SERVICE LETTER 240

INSTALL TOP DECK PUMP OUT CUP DUCKBILL VALVE

Aircraft Makes/Model(s):	Float Model(s):	Compliance: Optional	By: MAS
All Aircraft	All Float Models	Part Number: 1011979	Approved: DRH
		Date: 10/24/2025	Revision: E

Figure 1 – New Pump Out Setup

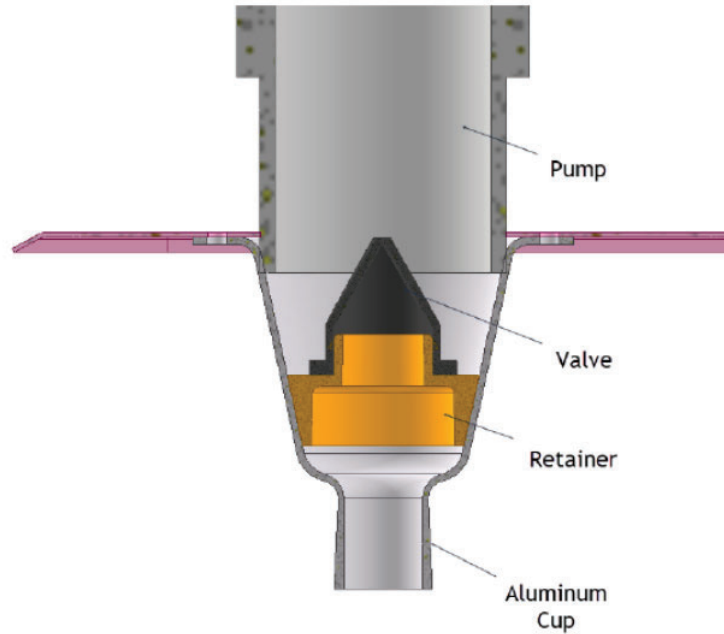
Pump out plugs p/n 2111 do not always stay lodged in the cup. A new design includes a retainer that is installed in the cup with clear RTV adhesive (or equivalent) and a rubber, replaceable "Duckbill" valve. This will also allow pumping out water from the float without pulling the plug. See Figure 1 at the end of this service letter. This letter also describes optional methods for increasing retention of the rubber duckbill component, which can be especially useful when exposed to contaminating fluids or prying wildlife. The snap ring retention method became standard from production in 2025.

- For each pump out cup:
 - Remove the current plug
 - Clean the cup from dirt and debris. Use IPA or proper cleaner as prep for adhesive.
 - Using clear RTV or equivalent (any color can be used), install the retainer in the cup.
 - After adhesive has cured, install the duckbill valve onto the retainer and secure with snap ring.
- (OPTIONAL) Measures for retention of duckbill valve if not already in place (see Figure 2):
 - Using snap ring pliers, install snap ring (see table for p/n) so that it is seated against the upper surface of the duckbill valve flange but below the barb of the retainer, or:
 - Clean the mating surfaces and apply RTV below/around the duckbill valve flange where it meets the retainer. Beginning with a few light dabs is recommended, increasing as required.

Figure 2 – Optional Retention Measures

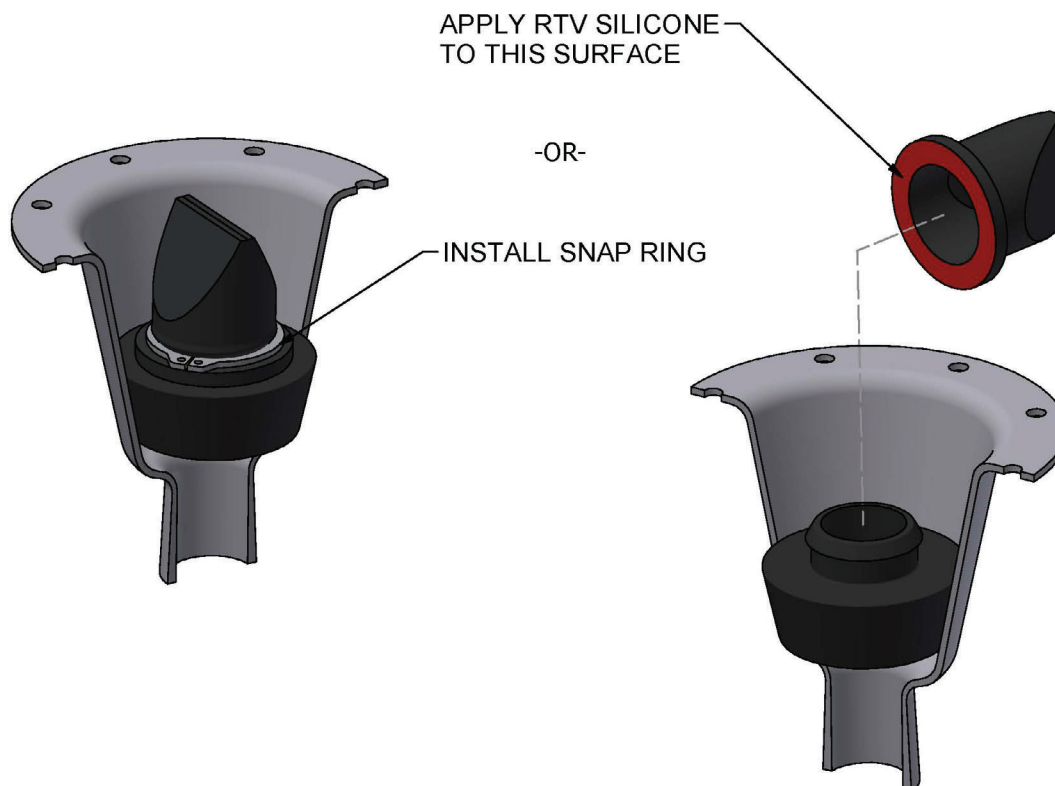
All floats. Those with pump out plugs p/n 2111 currently installed may use this service letter for retrofit. Those with the newer duckbill design already installed may wish to implement the retention methods described in step 2 of the work instructions, if not already in place from production.
